COMMUNICATION from the City Plan and Zoning Commission advising that at a public hearing held June 21, 2007, the members voted 9-2 in support of a motion to **APPROVE** the request from Mid-America Group (owner) represented by Theresa Wahlert (officer) for approval of a preliminary subdivision plat for "Harvest Hills Plat 2", located at 3930 Southeast 72nd Avenue (also known as E. Pine Avenue), on 137.85 acres of land, to include six (6) lots on 35.7 acres for general retail commercial use, three (3) lots on 18.3 acres for medium density residential use, 280 single-family residential lots on 68.2 acres, and a 7.3 acre outlot for recreation/open space use subject to the following conditions:

Request from Mid-America Group (owner) represented by Theresa Wahlert (officer) for review and approval of a preliminary subdivision plat, "Harvest Hills Plat 2".		File #		
		13-2007-1.50		
Description of Action	Preliminary subdivision plat on 137.85 acres of land, to include six (6) lots on 35.7 acres for general retail commercial use, three (3) lots on 18.3 acres for medium density residential use, 280 single-family residential lots on 68.2 acres, and a 7.3 acre outlot for recreation/open spa

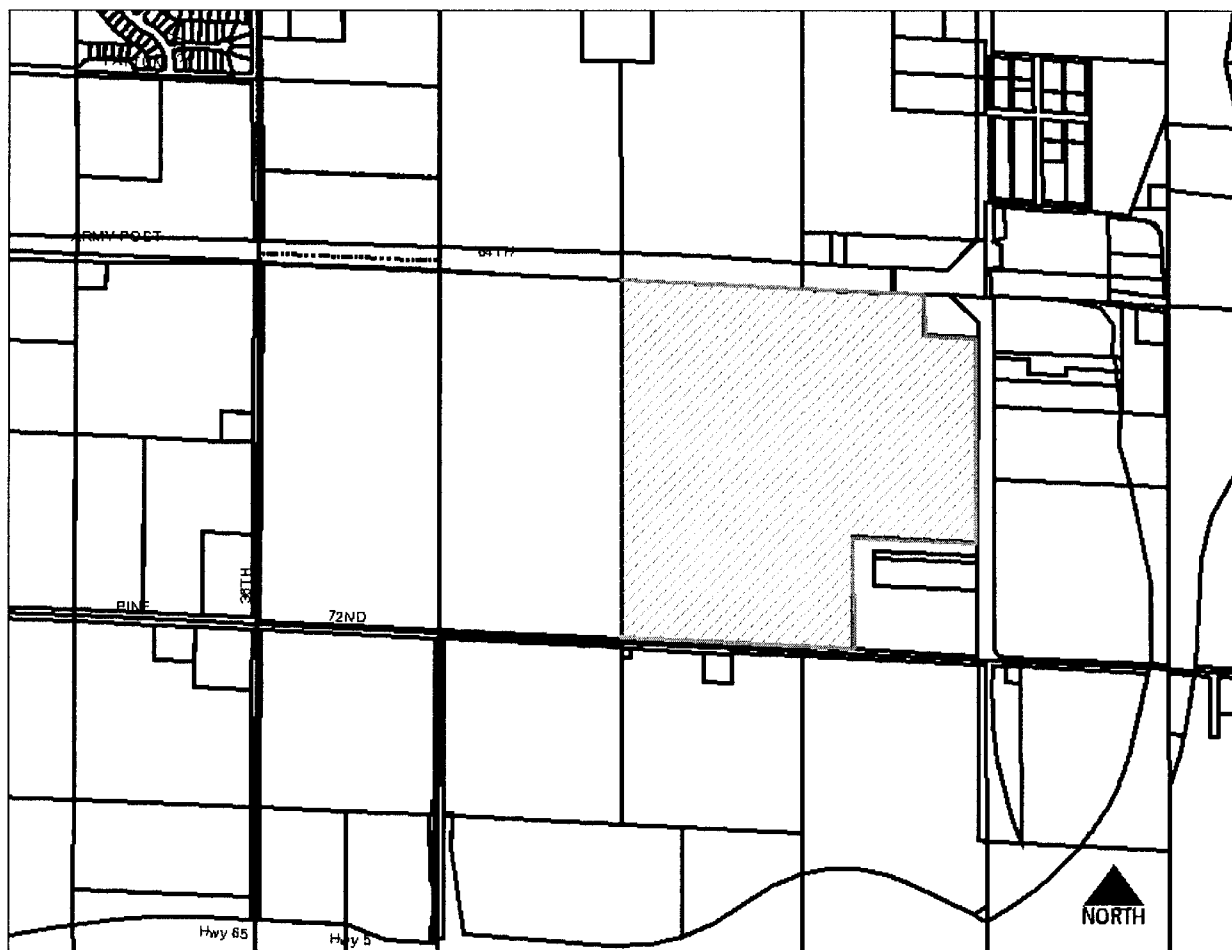
Tim Urban: Expressed concern regarding 72nd Street and the connections and asked if the circulation system in terms of its points of access to the surrounding arterial network was open for comment. Noted there are very few points of contact and the only contact between the current phase and the next phase is a single connection in the middle of the property.

Mike Ludwig: Explained the street network is consistent with the approved concept plan. Noted the applicant was directed to show the locations of the accesses because of the anticipated development. He suggested the Commission could recommend an additional east/west vehicular connection. He recommended reconfiguration of Lot 51 that currently comes to a point.

Tim Urban: Expressed further concern about there being no central point of access to allow pedestrians to get to the pathway running across the north portion of the property.

- widening of Army Post; if only along the applicant's property, may not be sufficient length of deceleration period;
- only one access on Army Post and one on 72nd for ingress/egress to the property;
- proposal to develop the most dense portion of their site first;
- traversing through the development east and west;
- approved conceptual plan; could have expected something different or some changes in terms of the actual platting;
- smaller lots at the north;
- ingress/egress into the parkland/school portion.

Tim Urban: Expressed concern that there was only one connection between the two phases and asked the applicant if they would consider the following minor connection changes to improve circulation:

- at the north;
- on the north side of the small R-3 area for sidewalk and traffic connection.

1. Annexation into the City of Des Moines.
2. Inclusion of notes on the Landscape/Preservation Guidelines that describe measures used to protect existing trees larger than 6" in caliper during construction and grading.
3. Provision of a right-of-way lot to the southeast to allow for future street connection to the east. Adjoining lots should be resized to serve as corner lots if necessary.
4. Compliance with all administrative review comments by the Permit and Development Center staff.

Tim Urban: Offered a friendly amendment that staff work with the applicant to consider increased connectivity within the two phase of the project and determine to what extent it could be improved for the circulation system.
